EMISSIONS RECALL CAMPAIGN 2A85 2018 GSX250R ECM Replacement

Affected Models: Certain 2018 GSX250R Models

Location of ECM

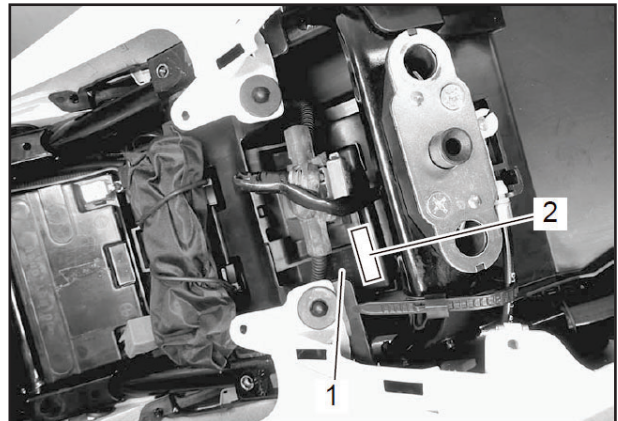
- 1) Remove the front and rear seats (Service Manual Section 9D Seat Removal and Installation).
- 2) Remove the frame center front cover (Section 9D Frame Center Front Cover / Frame Center Cover Removal and Installation).
- 3) Check the ECM (1) part number (2). If the current part number is **32920-20K31-RX0**, the repair does not need to be made. Reinstall the frame center front cover and the seats.

If the ECM part number is **32920-20K30**, proceed to the next step.

(1) ECM

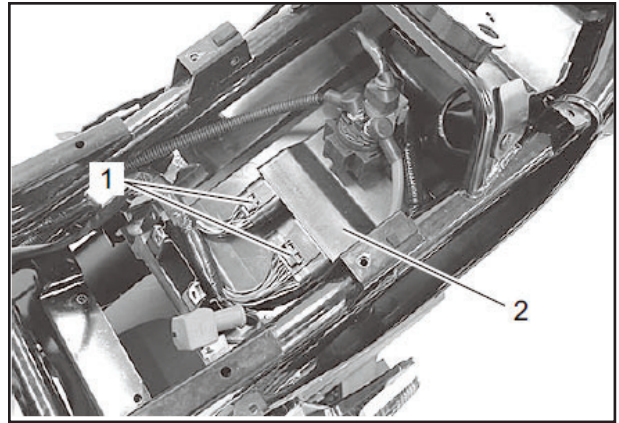
- 8) Disconnect the ECM couplers (1) and remove the ECM (2).

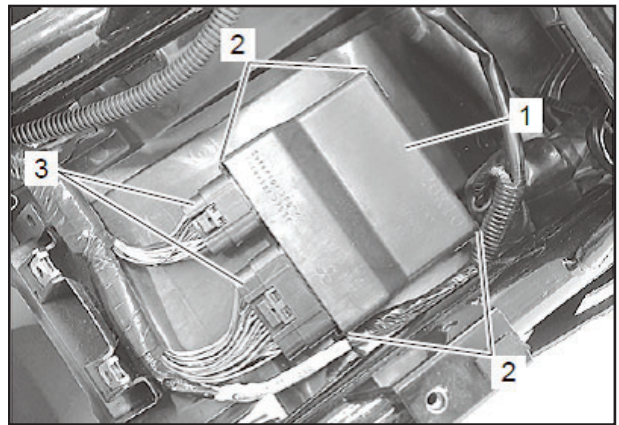
- 9) Install the replacement ECM (1) in the ribs (2) of the rear fender and connect the couplers (3).
